REQUEST FOR APPEAL

Project Address: 511 S. Oak Knoll Avenue, Pasadena CA, 91191  
Case Type (MCUP, TTM, etc.) and Number: DHP2024-00261  
Hearing Date: October 28, 2025 Appeal Deadline: November 17, 2025

**Subject:** **511 South Oak Knoll Avenue, Pasadena, CA**  
*Proposed Multi-Family Development*  
*Request for Appeal of 28 Oct 2025 Design Commission Decision of the Concept Design*

**East Profile of the Proposed 511 S. Oak Knoll Development.** Canyon Live Oak Tree OS1 is shown about 12 to 15 feet south of its true position. It actually crowds into (clash) the south building façade by many feet since the trunk is actually located approximately 3 feet from the property line.

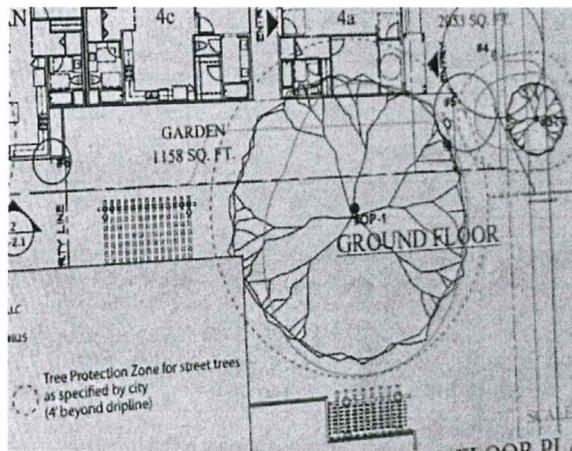
- The East Side rendering (Concept Design drawing AG-1.0) incorrectly shows the location the landmark Canyon Live Oak tree. It is actually located approximately 3 feet from the property line and considerably encroaches on the building superstructure (as currently drawn).

**Plan View of the Canyon Live Oak Tree OS1**  
Note the location and clash with the building façade

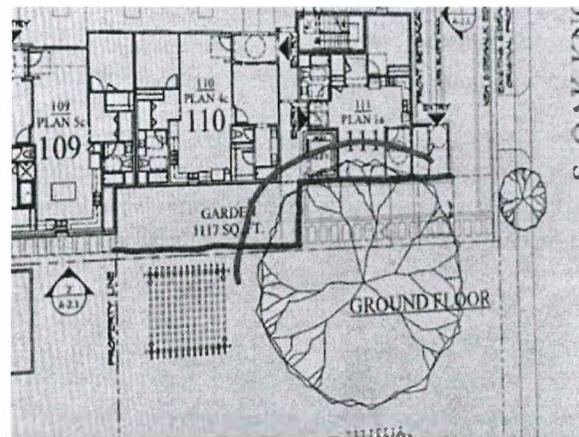
**Plan view of the Canyon Live Oak Tree OS1..**  
Approx. drip line shown in red. Building foundation in blue

The Appellants recognize some modification of the building foundation design to move away from the OS1 tree roots, however this is not a compliant Tree Protection Plan and called for the City Ordinances. Moreover, it does not address potential damage to tree branches (canopy) and a landscaping plan that embraces the location and health of the Canyon Live Oak Tree.

**Building Reflective Noise Issues**

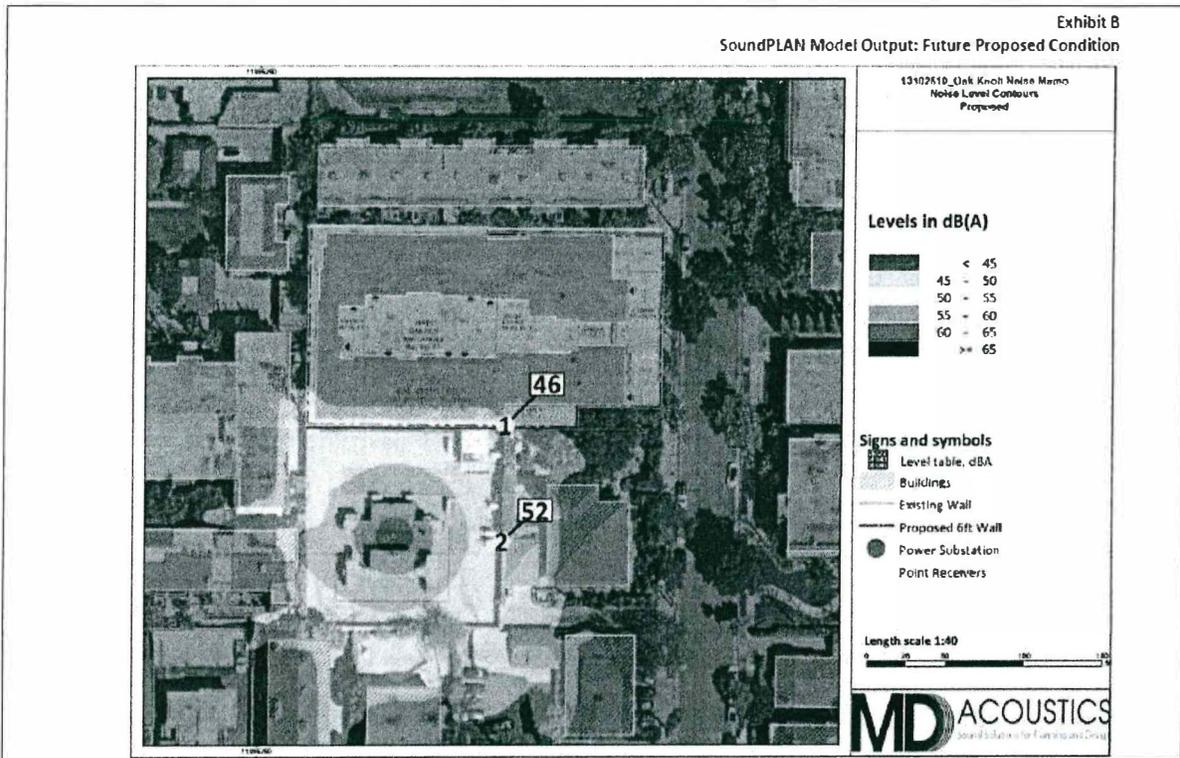
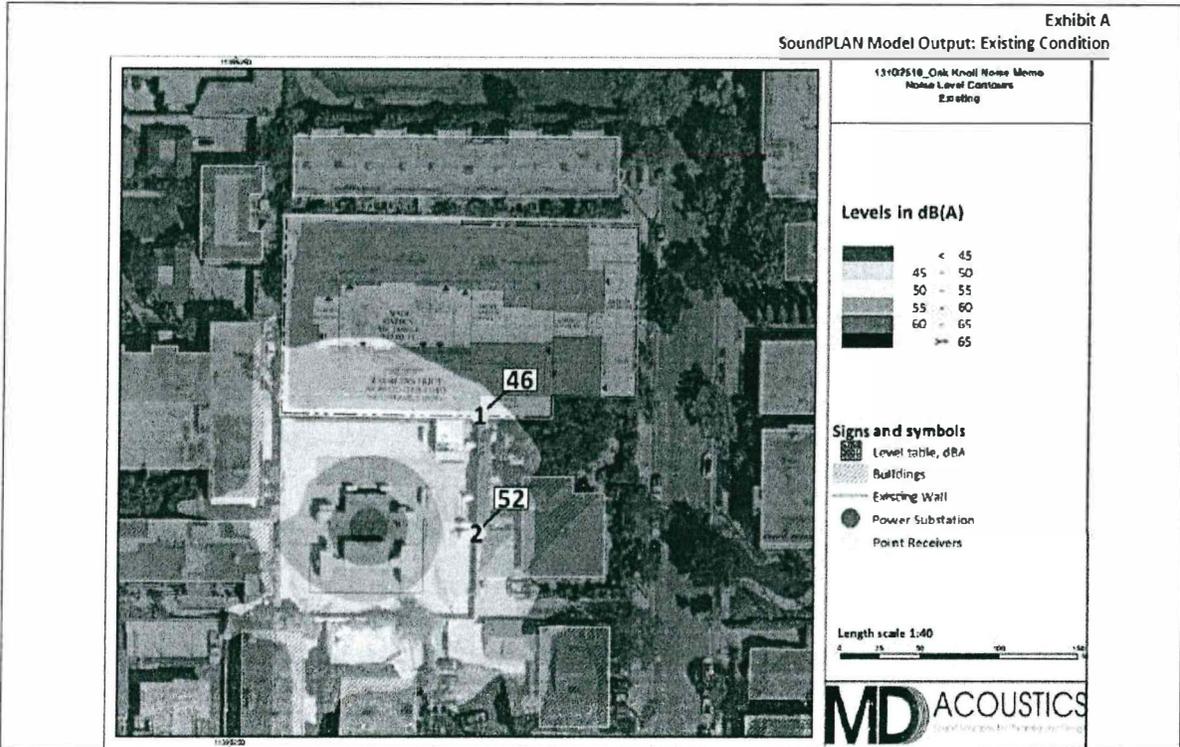
The conclusion in the above citation is erroneous. Actual nighttime ambient noise levels at the property are approximately 40 dB. The roof top HVAC units operating noise exceeds this level.

We are concerned that the proposed 4 stories of vertical building walls will reflect and amplify noise originating from the PWP substation to the adjacent properties surrounding the existing substation. After reading the latest report (MD Acoustics, LLC - listed below) and some further discussions with others with expertise in this field, we request the City require the following

Figure 1 511 South Oak Knoll Avenue, Pasadena, CA  
Proposed Development Site Plan with Comments

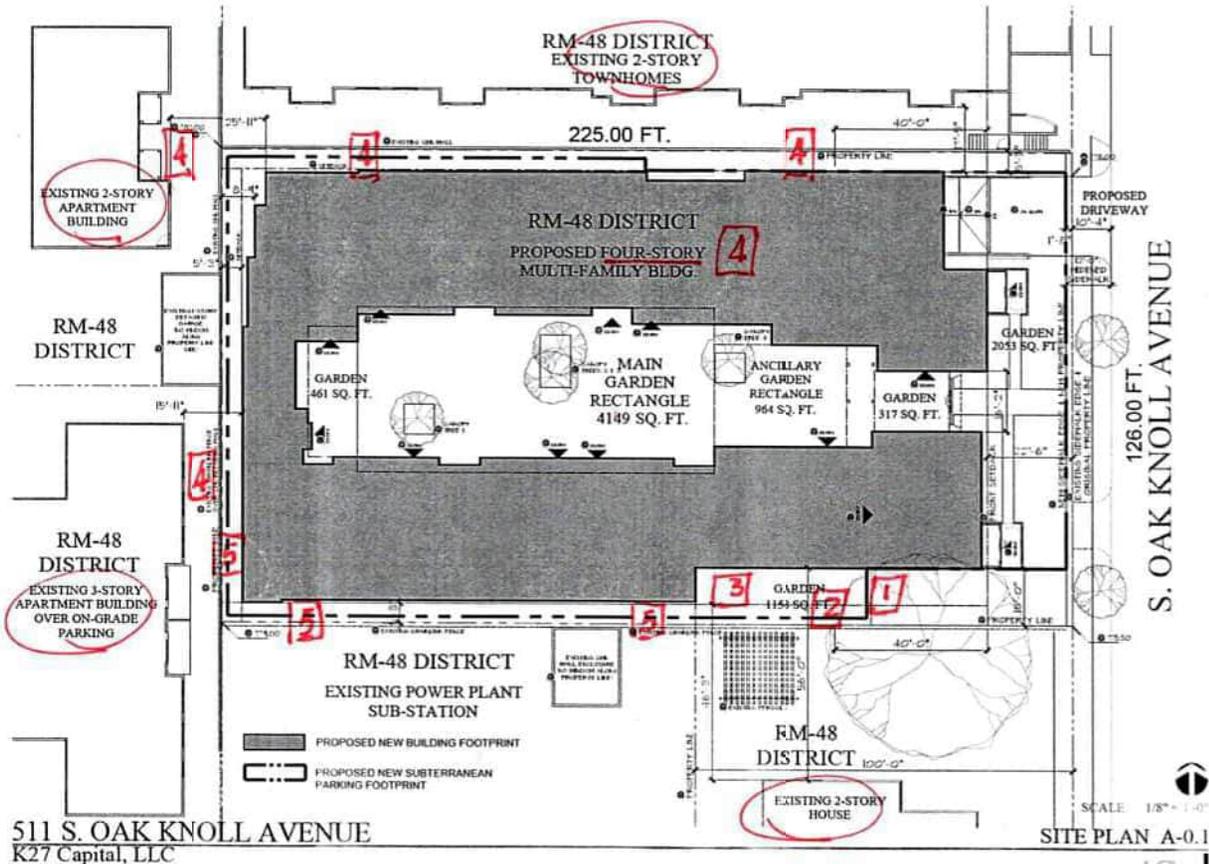
- [1] BUILDING WALL ENCLOSES ON TREE DRIP-LINE
- [2] SUBTERRANEAN WALL ENCLOSES ON TREE ROOT BULBS
- [3] PROPOSED GARDEN WILL HARM OAK TREE
- [4] PROPOSED 4-STORY BUILDING WILL OVERWHELM NEIGHBORHOOD AND BLOCK SUNLIGHT
- [5] VERTICAL 4-STORY BLDG WILL AMPLIFY NOISE FROM SUBSTATION

Figure 5: Tree shown with **Root Protection Zone** as shown on design submittal. Dotted line is on ground floor- that is **different** from the foundation level wall that extends outwards and further encroaches into the designated **Tree Root Protection Zone** (see next Figure).

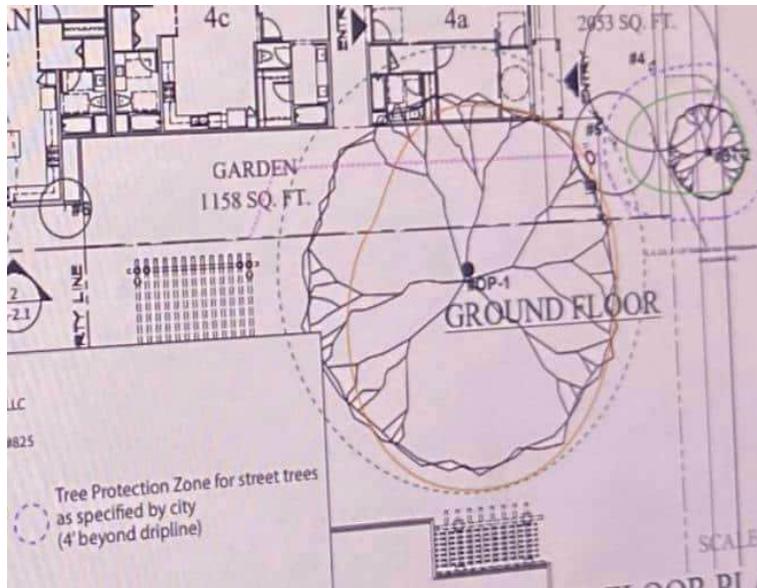
As can be seen in the Figures 5 and 6 below, as currently designed, the building foundation wall would intrude as ***much as 10 feet into the Tree Root Protection Zone***:

Thus, based on the present building design drawings, the basement walls encroach on the clearly identified **Tree Root Protection Zone**. Additionally, temporary building excavation shoring design and excavation methods for any subterranean structure have not been provided but shoring materials will of necessity be placed on the outside of the building foundation walls – such that shoring (e.g., piles and lagging) **will further encroach** on the tree roots and overhanging canopy. These conditions are unacceptable and must be corrected with a revised foundation wall design to avoid damage to the tree. We note that this design comment was also made in September 2024.

Figure 6: Tree Root Protection Zone (Red line) shown against Foundation Wall below grade (blue Line)

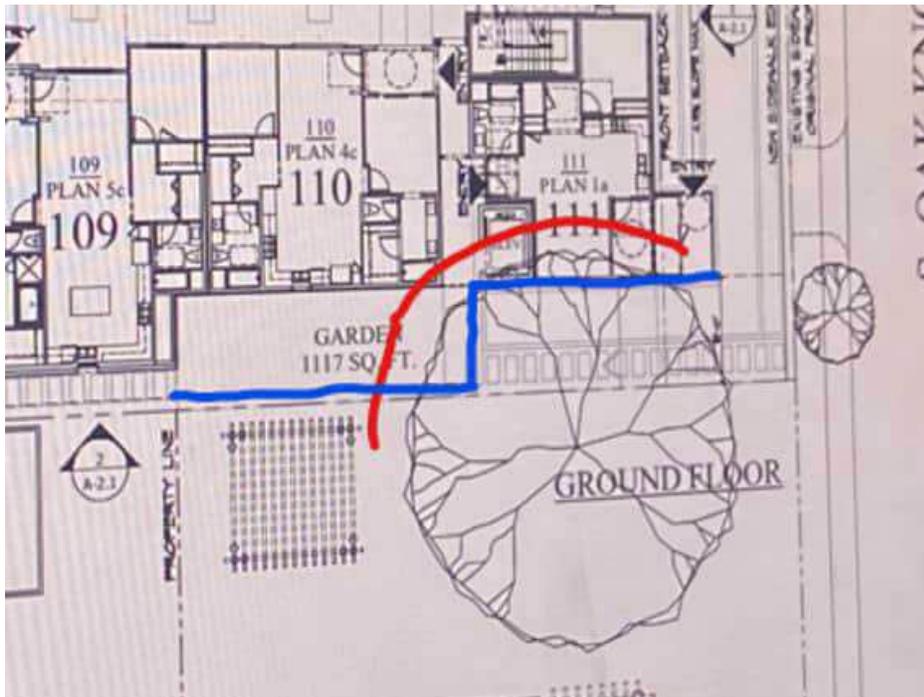
- Installation of excavation shoring walls (and the construction of the building above grade) will require tall, heavy equipment placed close to (and possibly under) the tree branches (canopy). The use of drill rigs and other heavy equipment on the tree branches could cause serious damage to the tree.

Figure 1 511 South Oak Knoll Avenue, Pasadena, CA  
 Proposed Development Site Plan with Comments

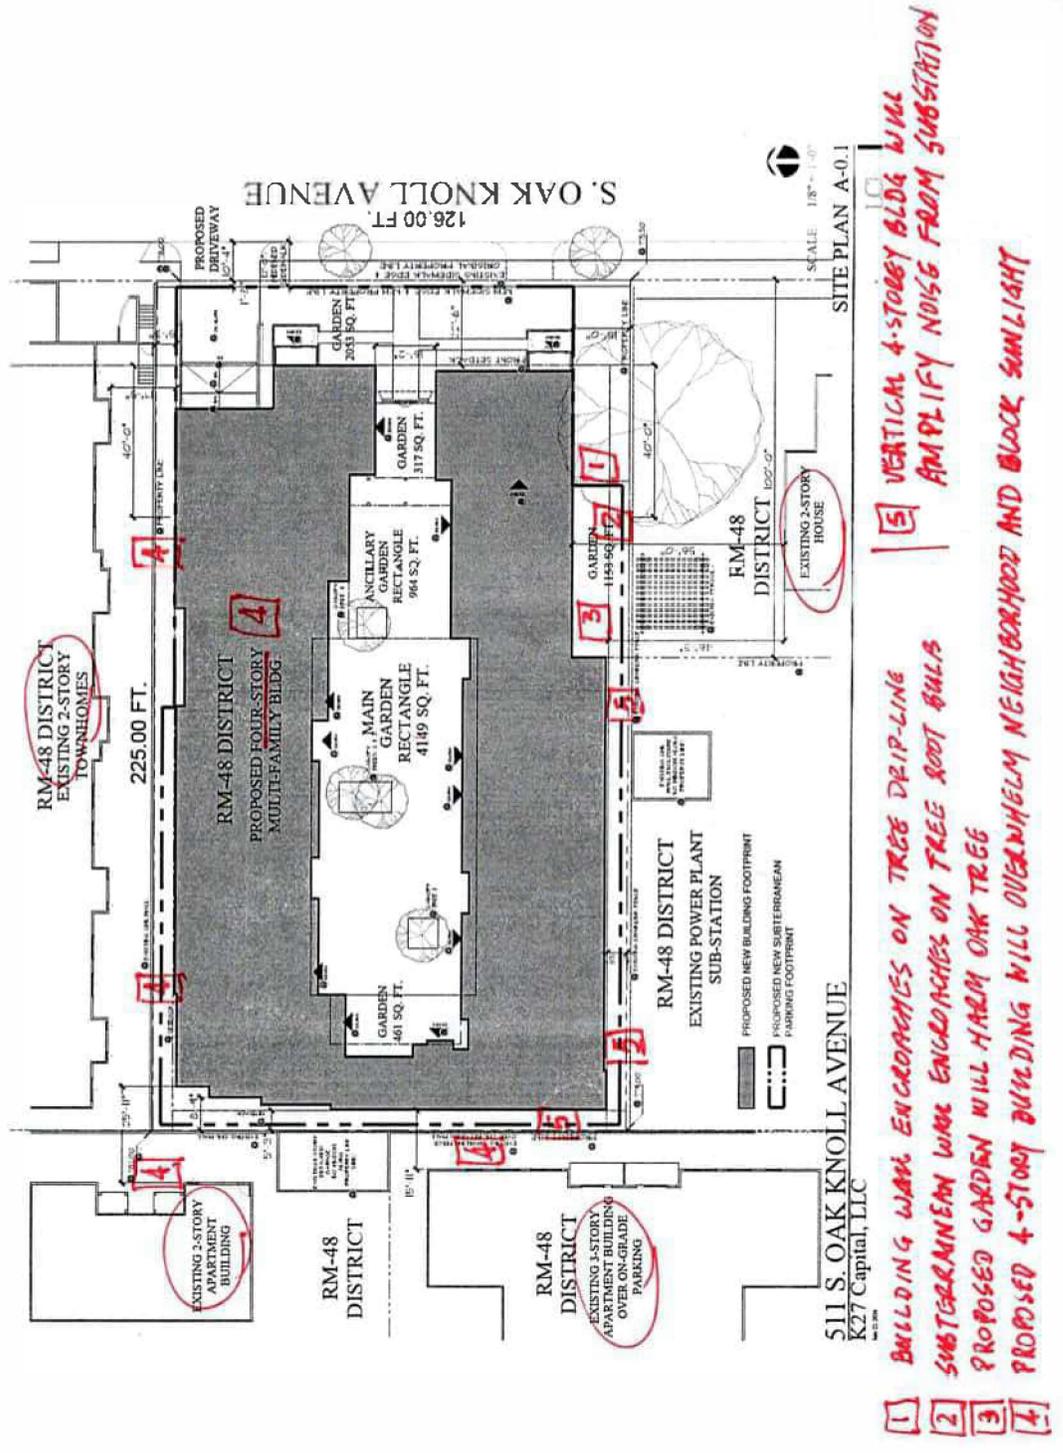
- The proposed multi-family building as shown in Figure 1 (as well as on all other design plan views) is placed too far south on the 511 property and, therefore, **significantly interferes with the Protected Tree**. Severe root and canopy interference issues are addressed in more detail below.

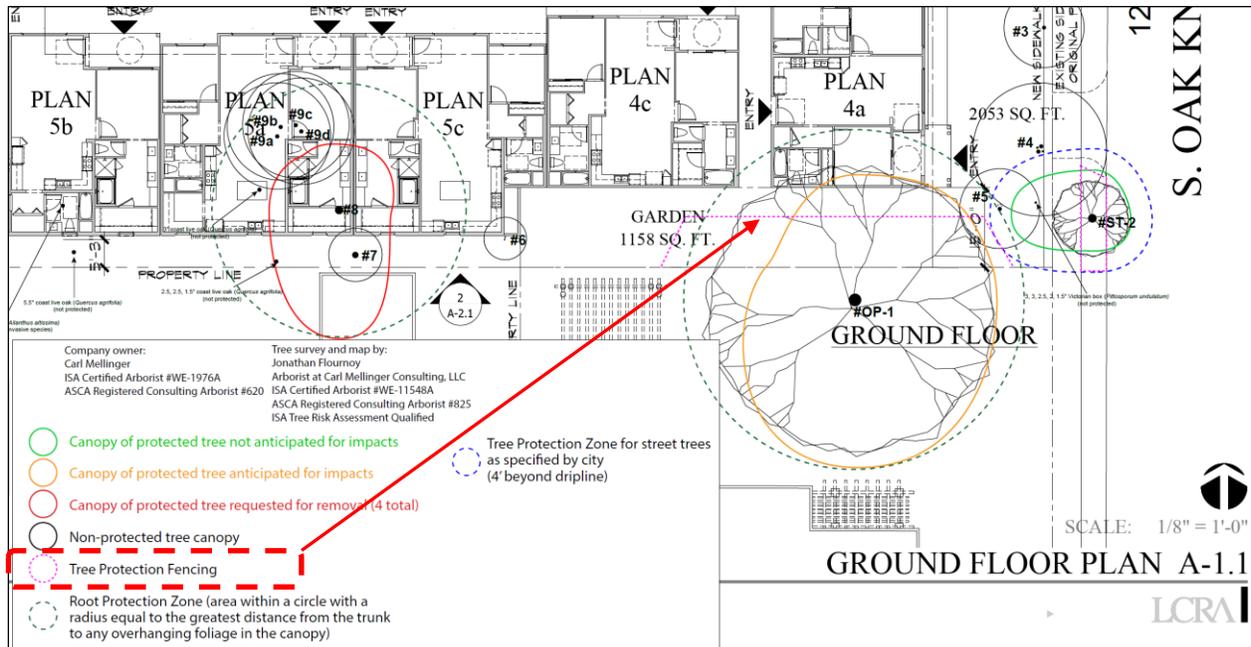
- **Tree Dimensions and Lean**
  - Diameter 36" DBH (drawing A-0.9 - Tree Plan and Inventory, of the Concept Design states 25").  
 [Note this is Native tree is well over the 8" diameter described in the Native and Protected Tree requirements]
  - Height overall 60 to 70 feet (estimated top of canopy) and is considerably taller than and adjacent Engine House 34 hose drying tower.
  - Width 60 feet (estimated canopy width) and variable
  - Lean Slightly to the south (sun side) towards 541 S. Oak Knoll single family Landmark residence and the Pasadena Water and Power Department electrical substation.
- **Tree Condition**
  - Excellent; green, leafy and robust. Please reference Figures 3a and 3b.
  - Very productive with acorns and popular with many squirrels
  - Inspected regularly by a licensed local Professional Arborist

**Figure 6a, 6b & 6c: Mandatory Tree Protection Plan and Canopy Images**

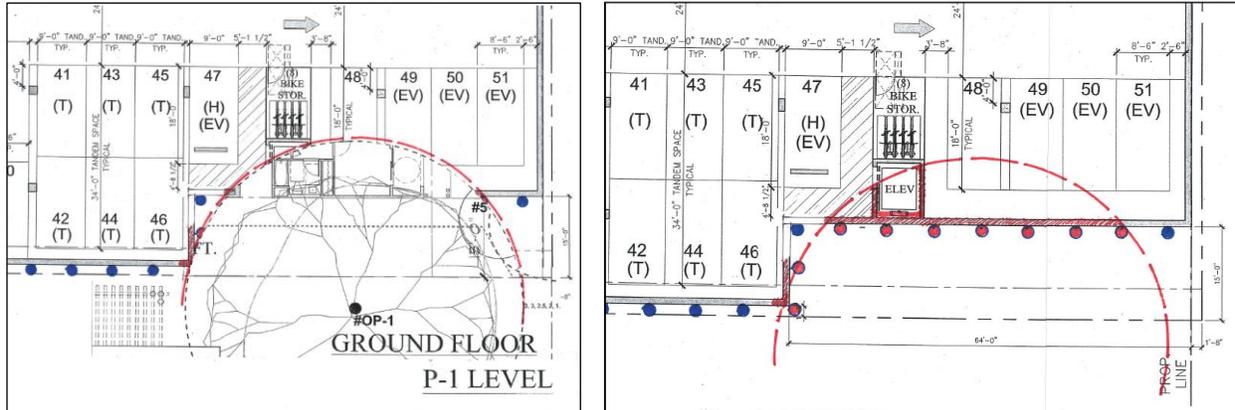
- Tree canopy perimeter
  - Tree canopy drip line (canopy + 4 feet radially from the tree trunk)
- The **Tree Protection Zone** (same as Root Protection Zone) needs careful definition, location coordinates and robust barrier fencing installation per the Pasadena Tree Protection Ordinance. Please see Figure 6a, 6b and 6c.

**Figure 8a & 8b: Mandatory Tree Protection Plan and Foundation Wall Interferences**

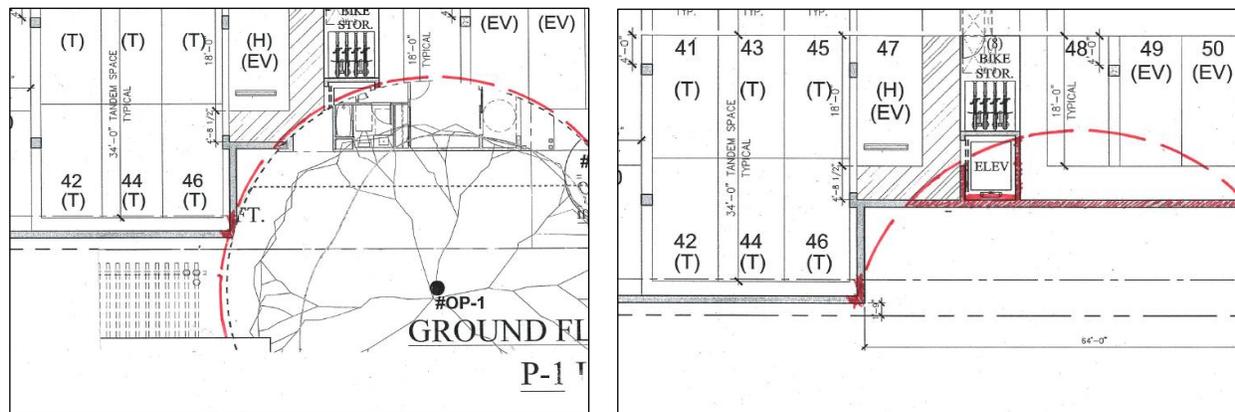
*Tree Protection Zone per TPO showing considerable interference from Support-of-Excavation for building foundation (left image) and placement on SOE element (right image) due to the over-size of the planned subterranean level. Assume pipe and lagging for SOE (typical). No additional space reservation(s) shown for SOE equipment and materials.*

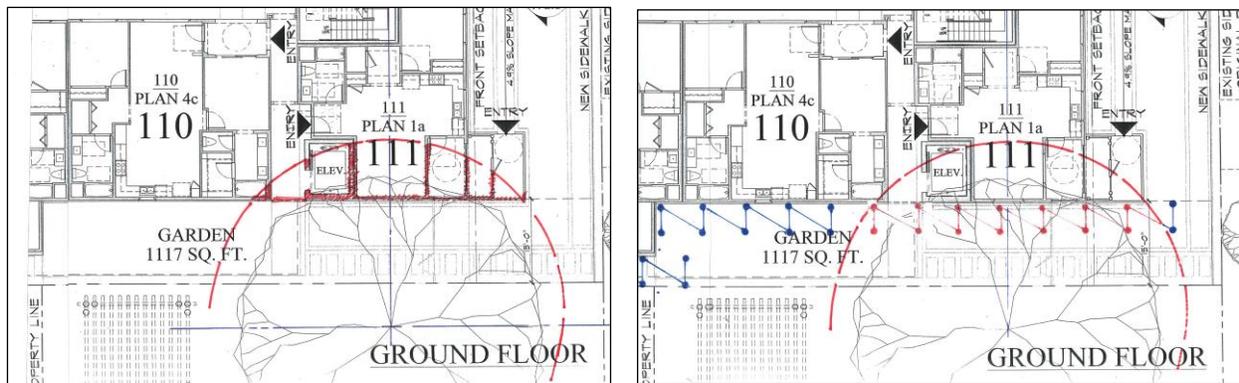
- The East Side rendering (drawing AG-1.0) **incorrectly shows** the location the landmark Canyon Live Oak tree. See Figure 1. It is actually located approximately 6 feet (tree trunk centerline) from the property line and considerably encroaches on the proposed building superstructure (as drawn).
- Based on several drawings and renderings provided with both the Preliminary and Concept Design submittals, a portion of the canopy (as drawn) conflicts with the building’s superstructure (by several feet) and perhaps on several floors.
  - Conflicts (clashes) would emerge during construction operations
  - Exterior access scaffolding would be in further conflict with the space
  - Material handling needs would be highly compromised.

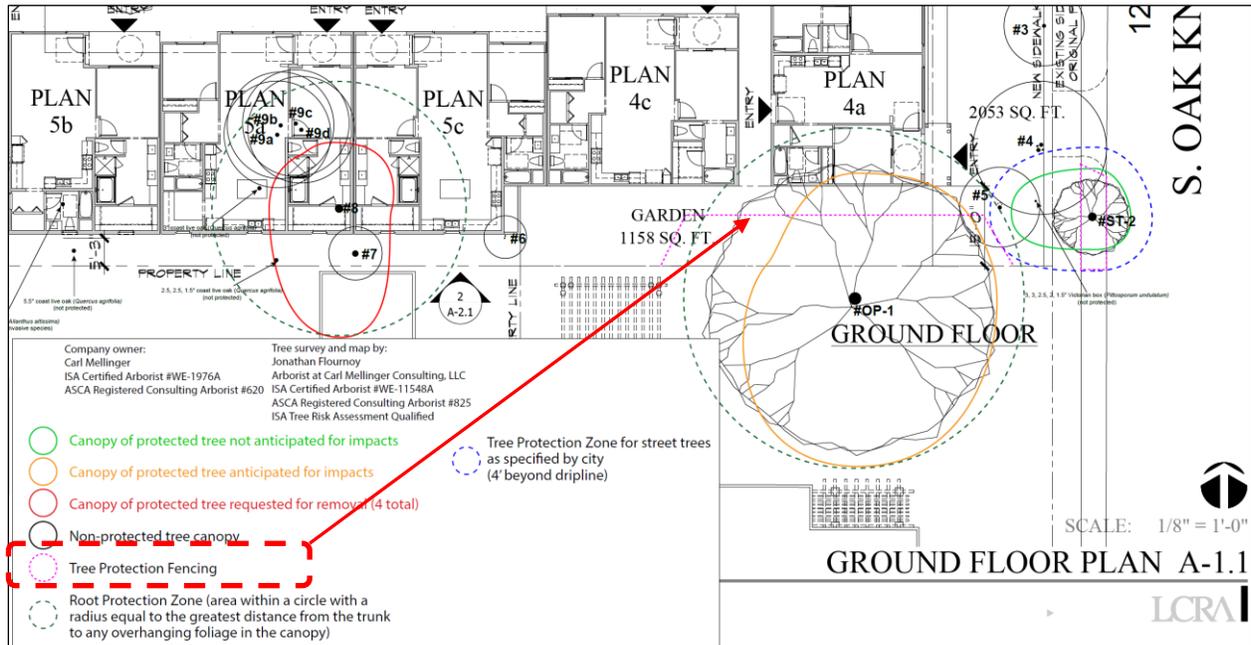
- **Canopy of Protected Tree** (Canyon Live Oak - **OP-1**) clearly shows an impact with the Superstructure in the proposed building.
  - The extended Tree Protection Zone per PMC 8.52 (for roots and canopy) further exasperates the extent of the impact.
  - The drawing does not show construction related impacts to be experienced in foundation and superstructure construction that further invade the designated Tree Protection Zone.
- **Location of the “Tree Protective Fencing”** as drawn is incorrect and completely erroneous. See Figure 10.
  - Fence is NOT in compliance with the Pasadena Tree Protection Ordinance (PMC Chapter 8.52) and other related documents.
  - Leads to a flawed foundation layout and building superstructure design (dimensioning) resulting in severe intrusion into the designated Tree Protection Zone and tree damage.

- **Drawing A-0.9 – Tree Plan and Inventory**
  - Shows (Canyon Live Oak - **OS-1**) protected tree as having approximately 24” diameter. This tree is approximately 36” diameter (DBH).
- **Topographical Survey (Southand Civil Engineering and Survey, LLP)**
  - Shows (Canyon Live Oak - **OP-1**) protected tree as having approximately 24” diameter. This tree is approximately 36” diameter (DBH).
